RTL8111E/RTL8105E 48Pin Reference
Schematic V107

Change Notice from 1.00 to 1.01

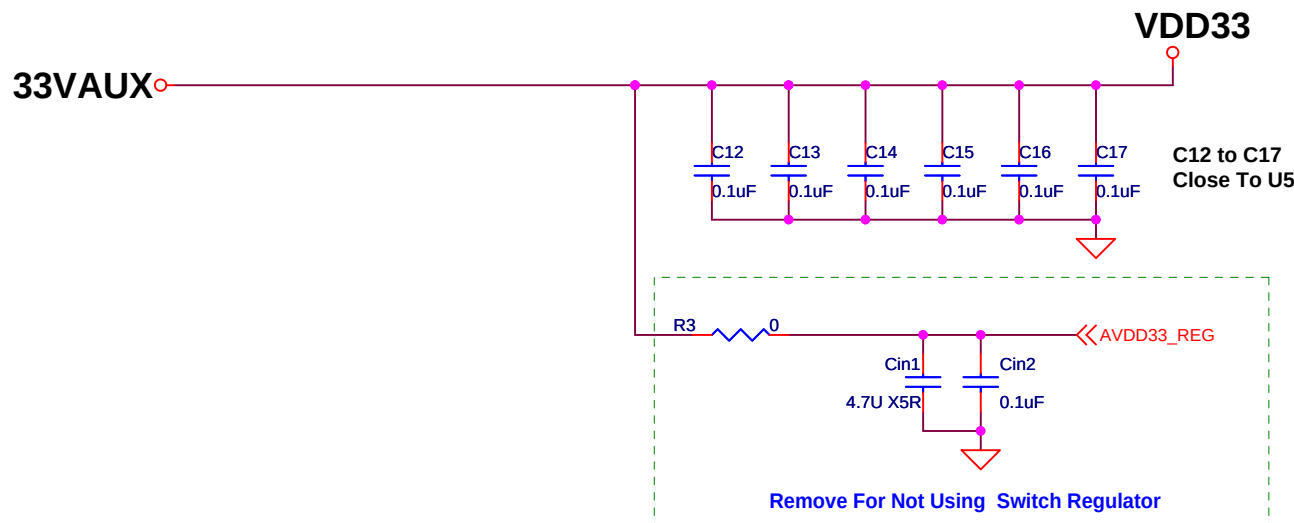
1. Update Pin name(Pin3, Pin47) For RTL8105E.(Page 3.)
2. Update Capacitor Description For RTL8105E and RTL8111E. (Page 2.)
3. Modify Center tap Schematic for Power Optimization. Center tap short and coconnector 1uF to GND.(Page 3.)
4. Add RTL8105E Optional Function Schematic.(Page 4.)

1. Add Resister For SMB Bus.(Page 3.)
2. Add C26 Value Note.(Page 3.)
3. Add SWR Power Sequence Note.(Page2.)

1. Modify Power Mode Table. (Page 2.)
2. Remove C4, C16 For RTL8105E-VC. (Page 2.)
3. Modify Lx Value and Update Note. (Page 2.)
4. Modify C26 Value Note. (Page 3.)

For RTL8111E-VB EEPROM / ASF / Efuse Function (3 Option)

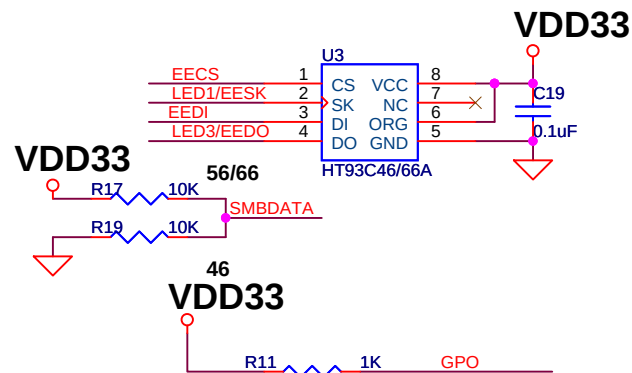
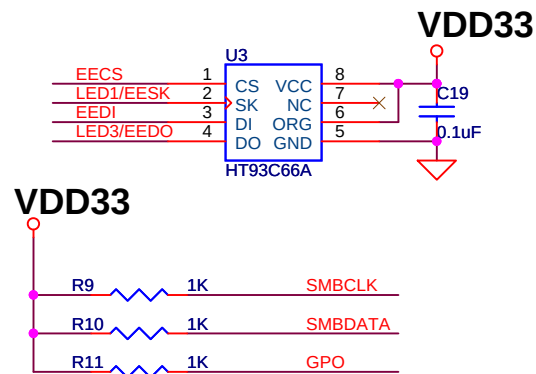
1. Modify Efuse Autoload Schematic, SMBDATA Pull Down. (Page 4.)

1. Remove TWSI Schematic. (Page 3 & 4.)
2. Remove TWSI Share Pin Name. (Page 3 & 4.)
3. Add Note For Lanwakeb & Clkreqb.(Page 3.)
4. Add Note For Function Option for Using Efuse/BIOS Patch.(Page 4.)
